MEMORANDUM

Case # 15-05

SUBJECT: Proposed Revisions to Detail 270 and Section 616 (UPDATE)

616.2 MATERIALS:

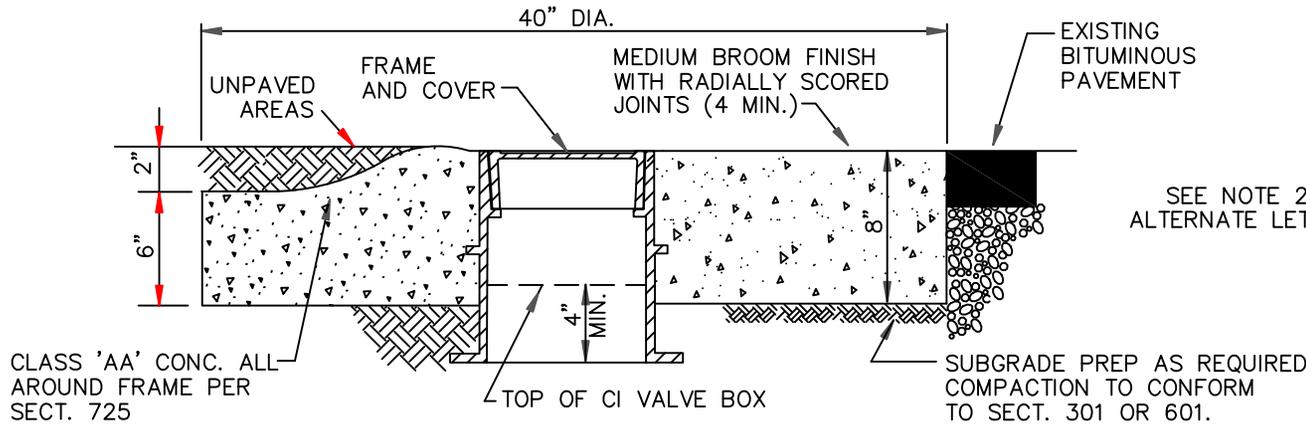
- New “SQUARE FRAME AND COVER AND GRADE ADJUSTMENT” Detail 270-2.
- Revise current Detail 270, FRAME AND COVER to “ROUND FRAME AND COVER” and revise detail number to 270-1.
- Revise Section 616 Reclaimed Water Line Construction as follows:

Pipe materials shall be in accordance with Section 610.

Valves shall be in accordance with Sections 610 and 630.

Valve boxes shall be in accordance with Section 345, this Section and Detail 391-1 and 391-2. Frame and cover shall be in accordance with Detail 270-1 or 270-2, per Agency requirements. Manholes shall be in accordance with Section 625, 787 and this Section, and applicable Details.

C.I. FRAME AND COVER

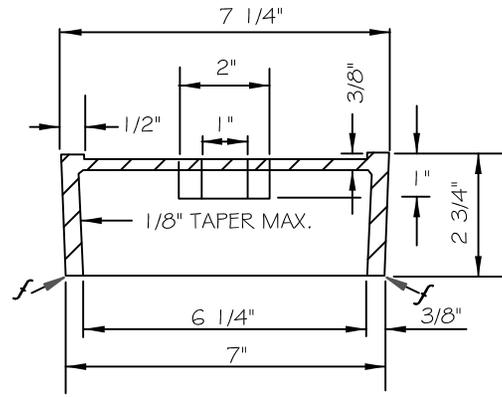
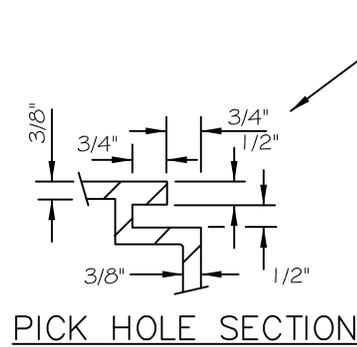
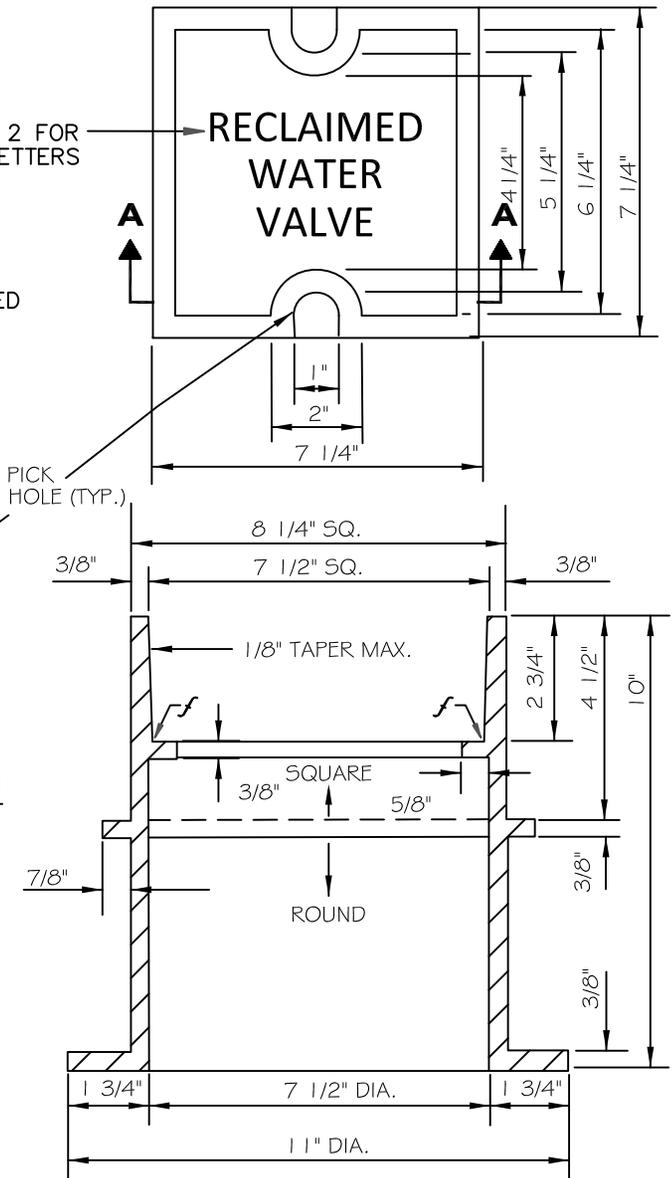
Purpose: Incorporate a square frame and cover intended for reclaimed water valve construction meeting ADEQ requirements (option to colored purple)
